| Department; **Outfitting System Design 1** | Ship Type; **157,000DWT Crude Oil Tanker** | Class.; **LR** |
| Approved by ; Y. S. Kim<br>Checked by ; Y. S. Park<br>Prepared by ; H. B. Choi (T.5572) | Document Title; **PIPING DIAGRAM OF ENGINE ROOM** | |
| **SAMSUNG HEAVY IND. CO., LTD.**<br>**GEOJE SHIPYARD, KOREA** | Builder's Document No.; **MB10100** | Rev. No.; **C** |

REVISION HISTORY ( 1/ 1 )

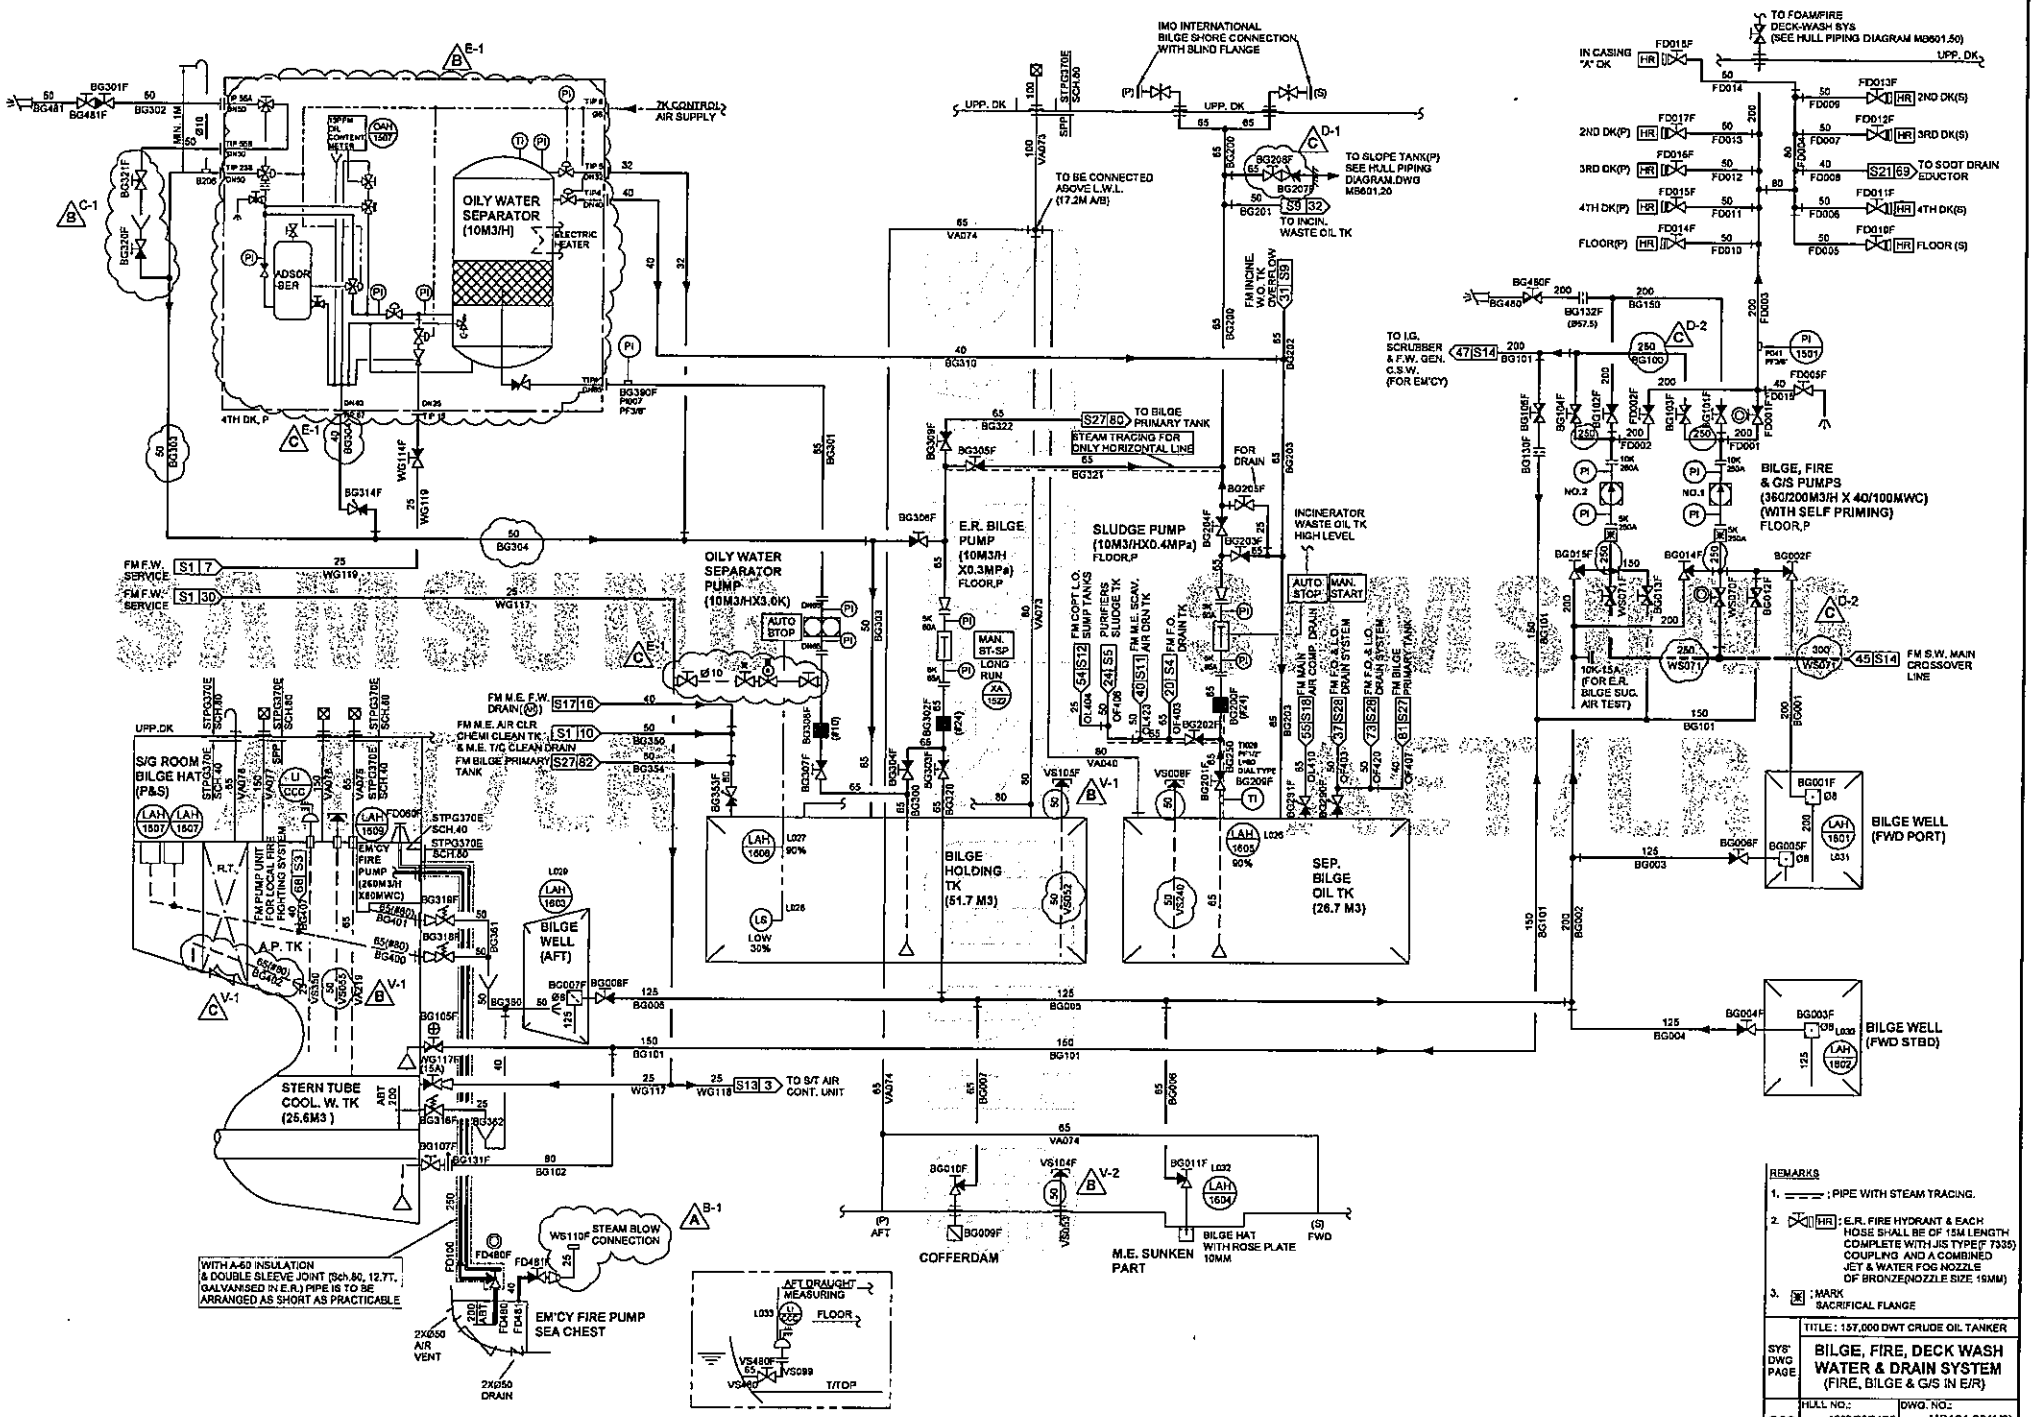
| ALT. NO. | REV. NO. | DESCRIPTION | SYS. PAGE |
|---|---|---|---|
| | E-1 | - Maker drawing for Oily Water Separator was changed and the relevant pipe line size was changed. | S26 |
| C | D-1 | - The valve type was change to stop valve and swing check valve instead of screw down stop check valve. | S26 |
| | D-2 | - The relevant pipe line of Bilge, fire &G/S pumps suction/discharge was modified as per actaul arrangement. | S26 |

| SYS' DWG PAGE | TITLE : 157,000 DWT CRUDE OIL TANKER<br>MISCELLANEOUS SYSTEM<br>(AIR COND. & REF. RROV. PLANT REFIGENANT) | |

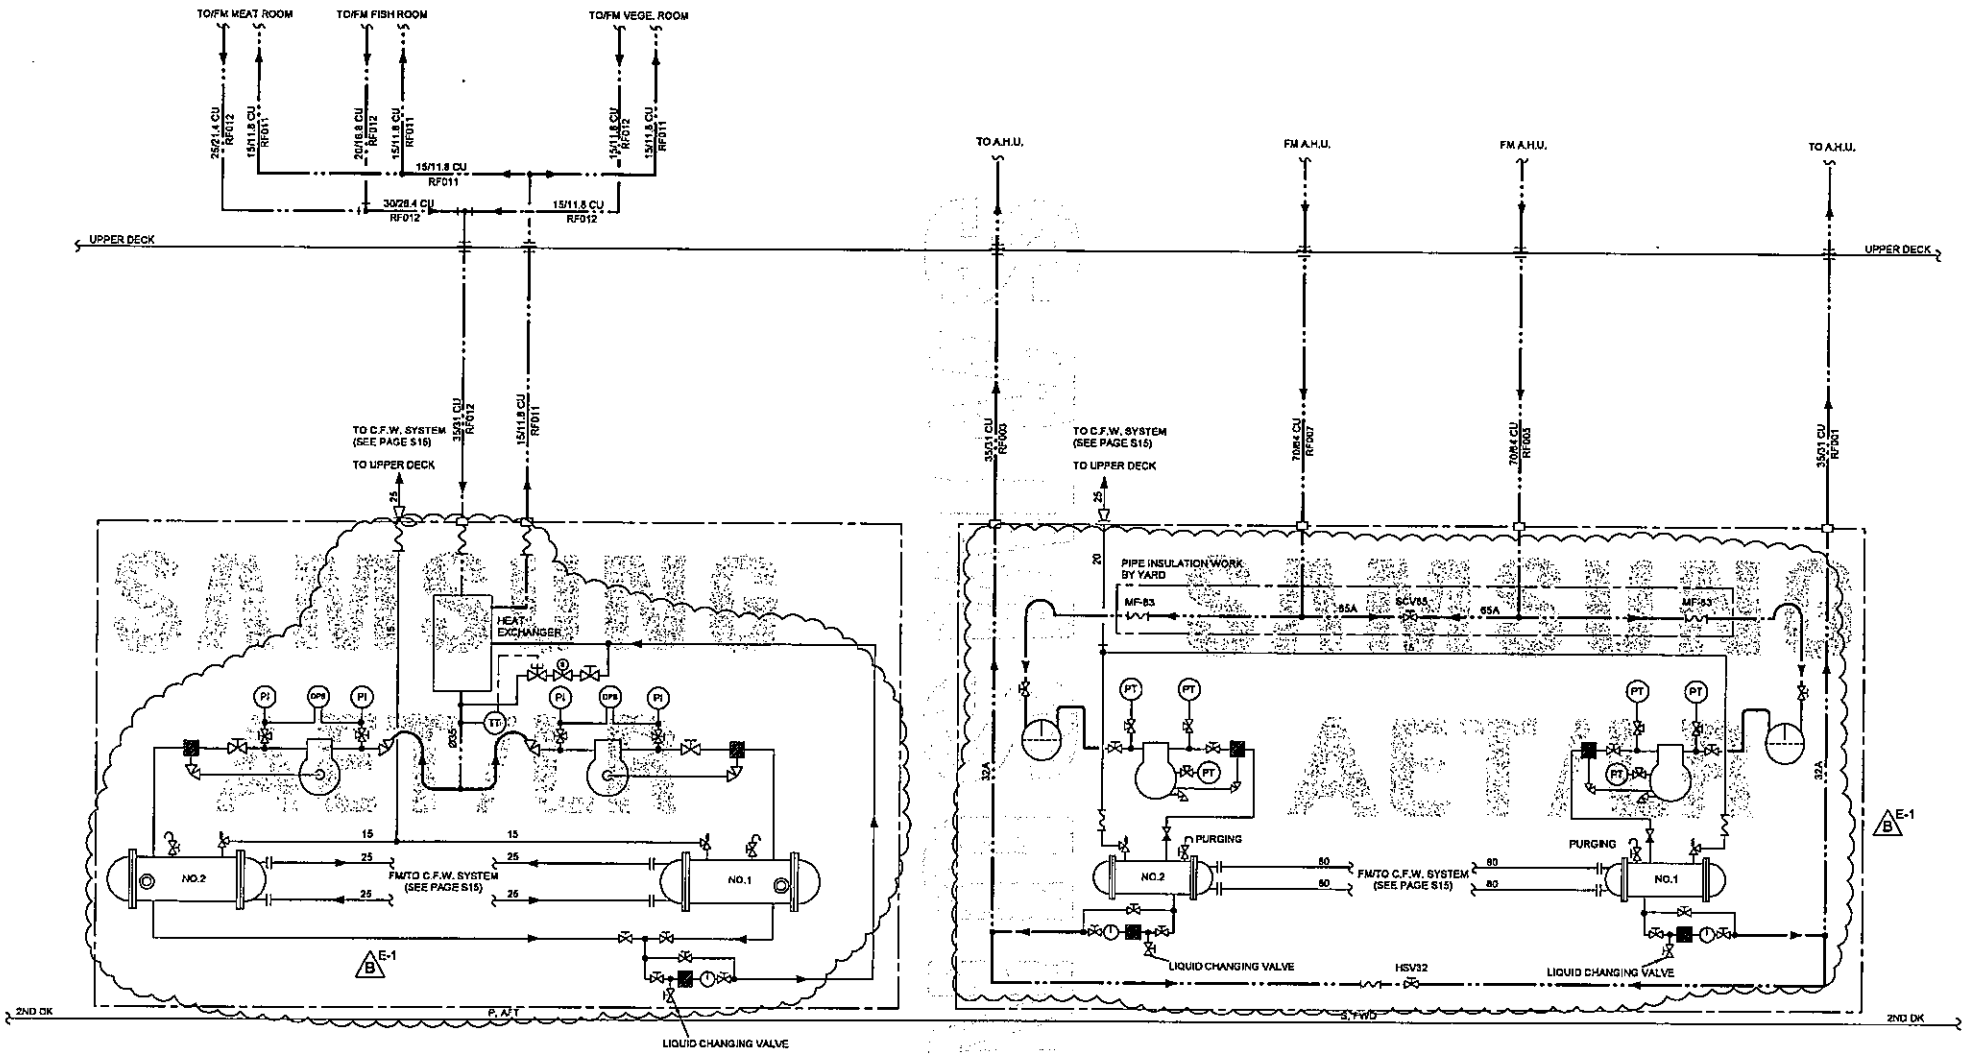
| ALT. NO. | Rev. NO. | DESCRIPTION | SYS. PAGE |
|---|---|---|---|
| B | E-1 | - Internal drawing of Ref. provision plant and Air condition plant was changed. | S29 |

| | M.E. M.D.O. CHILLER UNIT SYSTEM |

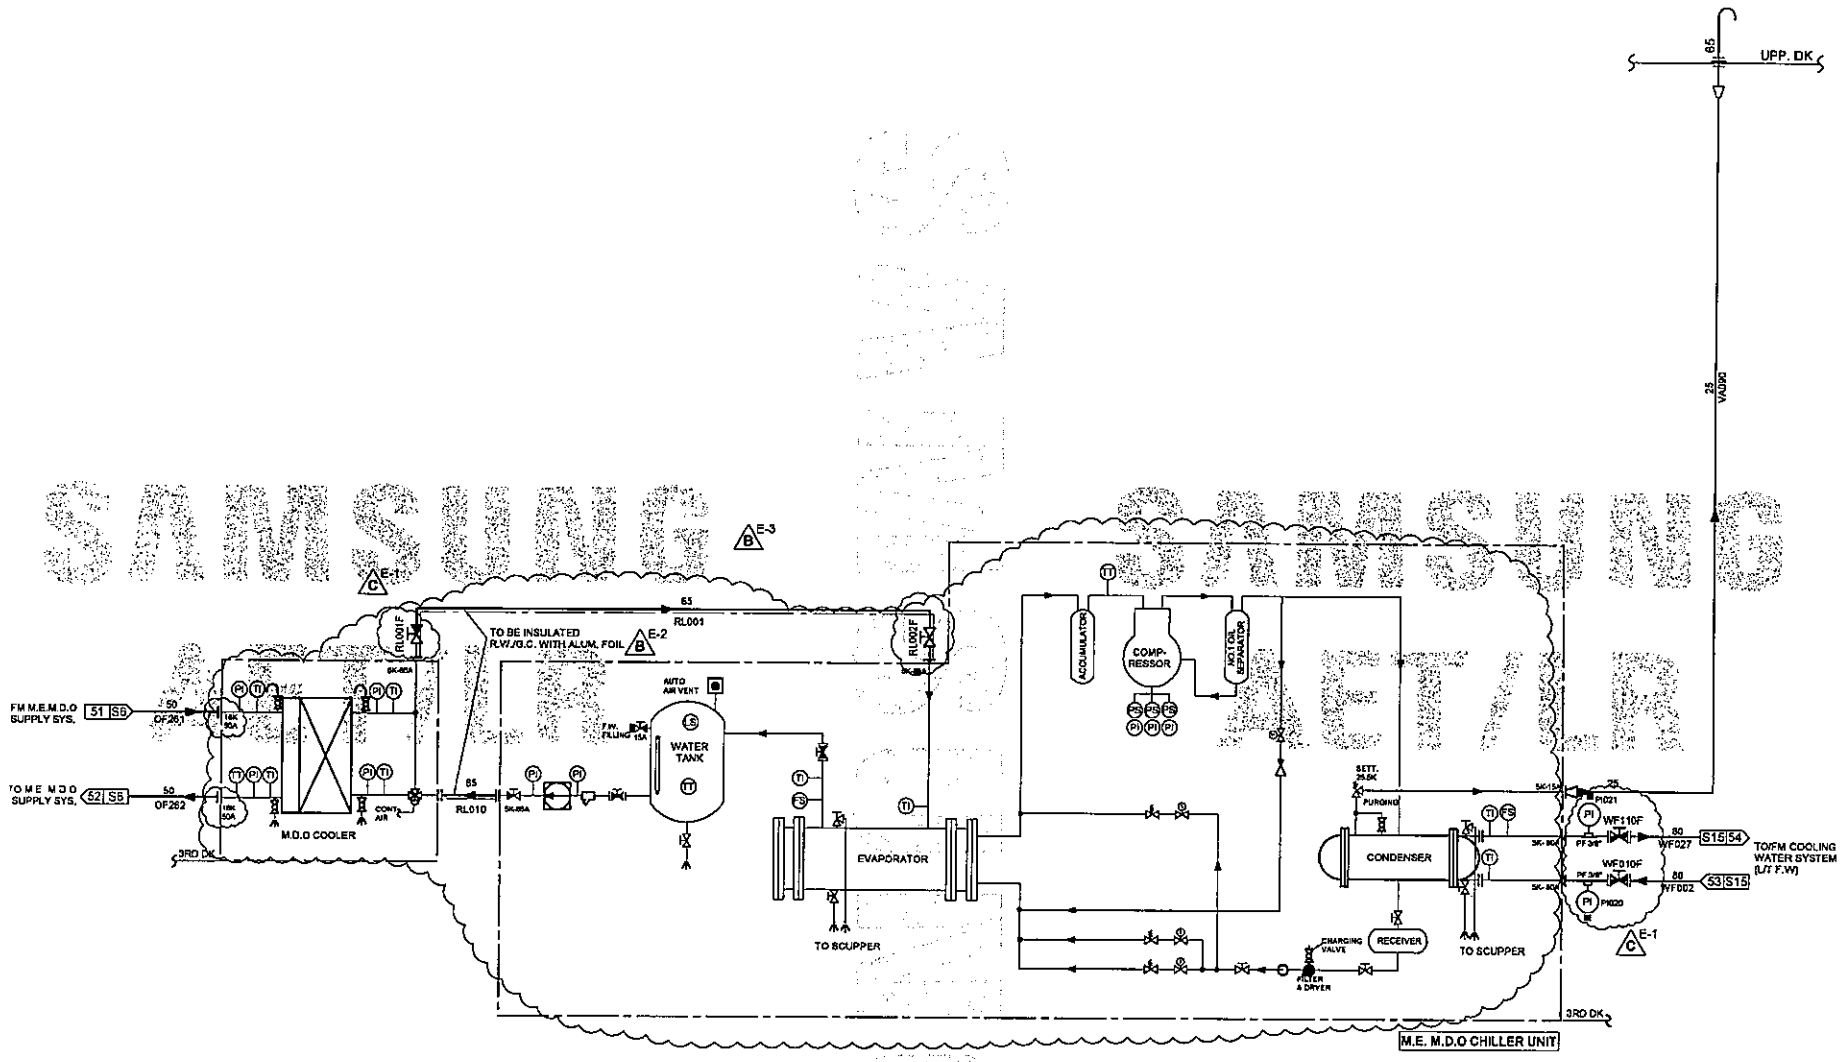
| ALT. NO. | Rev. NO. | DESCRIPTION | SYS. PAGE |
|---|---|---|---|
| | E-3 | - The relevant drawing for M.E. M.D.O. Chiller unit was changed. | S31 |
